## Remarks

### Response to Office Action

FIG. 2a

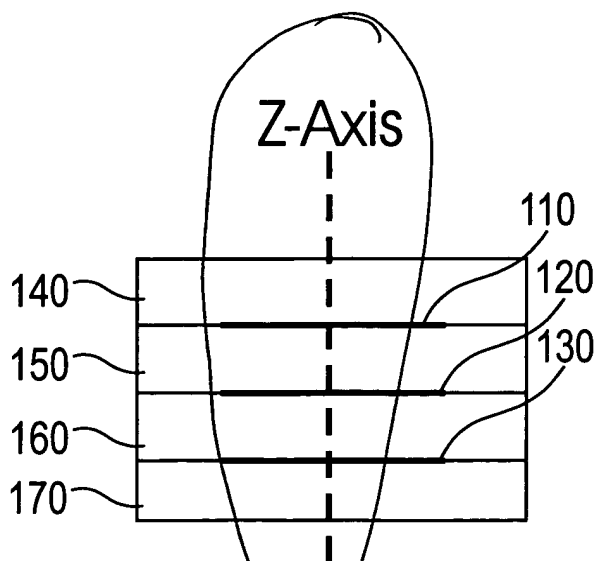
Also, for each individual drawing figure, each reference label therein needs on explicit description. For example, fig 2a (140, 150, 160, 170); figs. 5a, 5b (310, 320); fig. 6 (320, 501), etc. need explicit description relative to the corresponding specifications description of the drawing. Appropriate correction is required.

The drawings are objected to because of the following: In fig. 2a, the --Z axis--needs to be shown;

The specification has been amended to include reference labels 140, 150, 160, 170 at an appropriate section of the disclosure. See replacement paragraph beginning at page 5, line 27.

A replacement drawing has been provided showing the "Z-axis".

FIG. 12

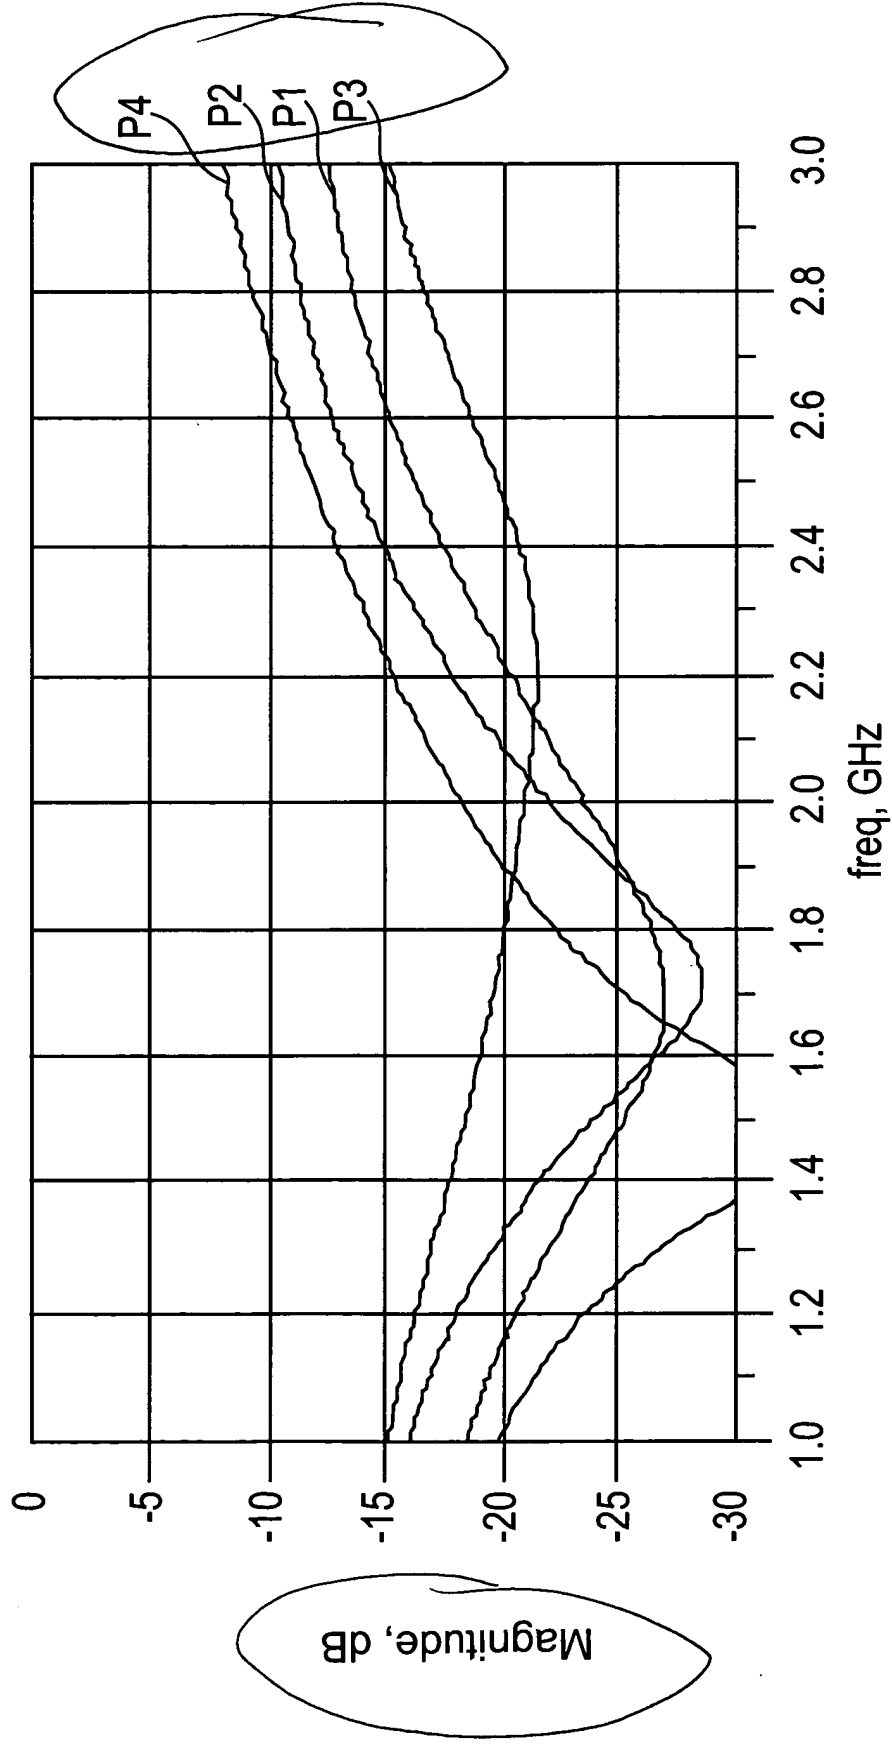
In figs. 12-17, note that (P1, P2, P3, P4) need to be labeled as per the specification description (see p 13, ls 21-26);

Replacement drawings have been provided with labeling P1, P2, P3, P4 added as appropriate.
